# SERVICE INFORMATION

## STANDARD AND TRIUMPH VEHICLES

<b>No.</b>	SPORTS/2/M	FLASHING SIGNAL LIGHTS	<b>Date</b>	FEBRUARY 1954
------------	------------	------------------------	-------------	---------------

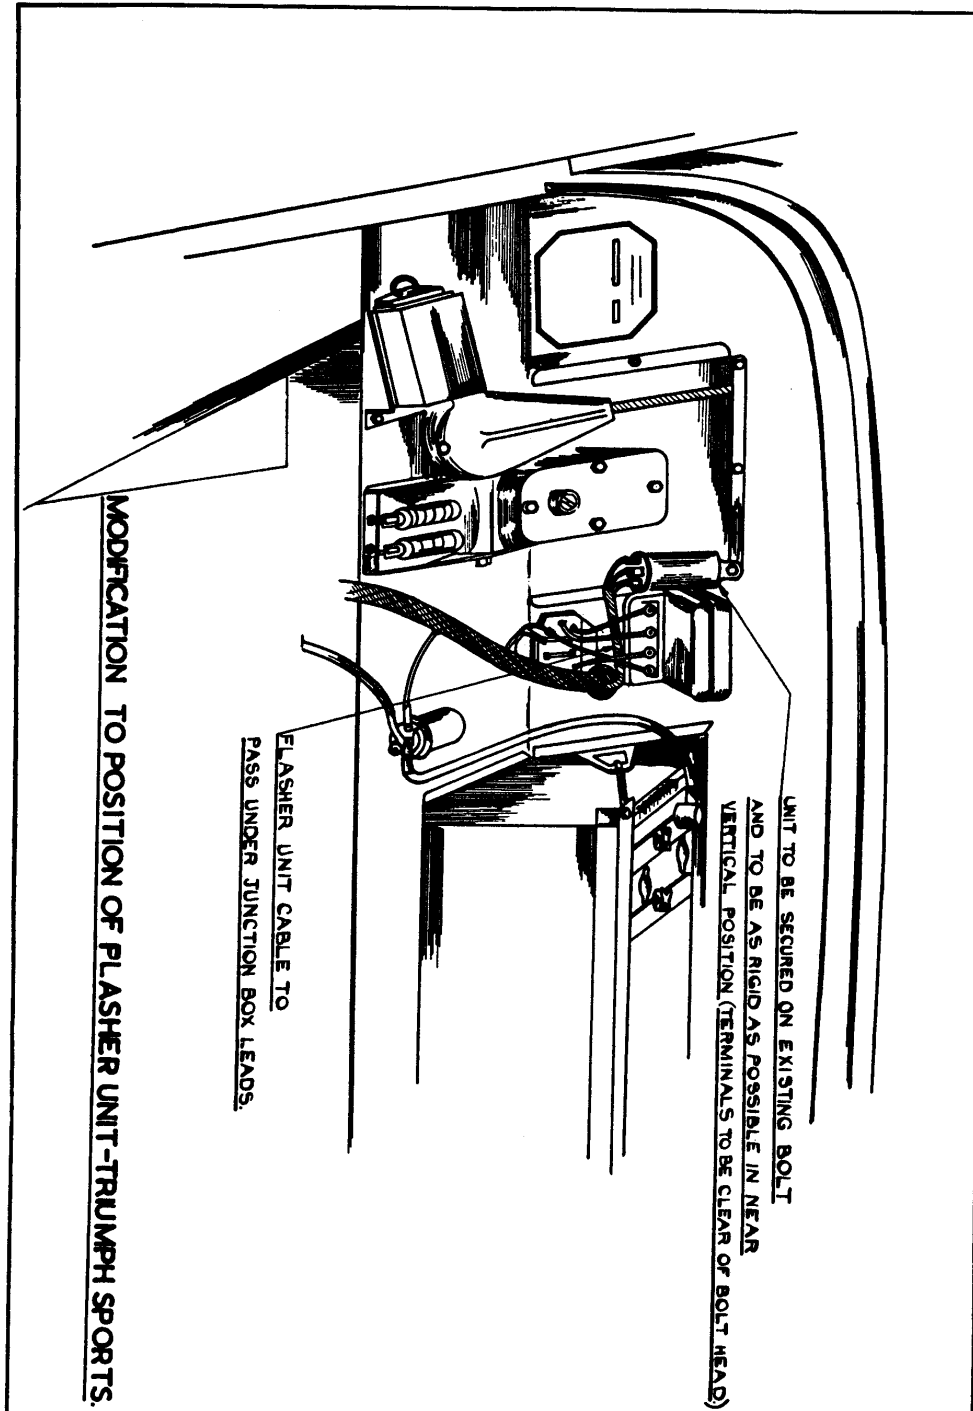
This vehicle is fitted with flashing type indicator lights and trouble has been experienced with the failure of the flasher control unit, Part No.107594.

This unit has been fitted horizontally and investigation by Messrs. Lucas has shown that the heat given off by the resistance is affecting the hinge of the contact strip, causing distortion and incorrect operation.

This unit is now fitted vertically (terminals pointing down the scuttle panel) and any replacement units must be fitted in this manner. It is possible to do this without modifying fixing bolts or harness and the latest position is shown in the illustration.

This change was incorporated in production during the month of February, but it is unfortunately impossible to quote a Commission Number at which the change was introduced.
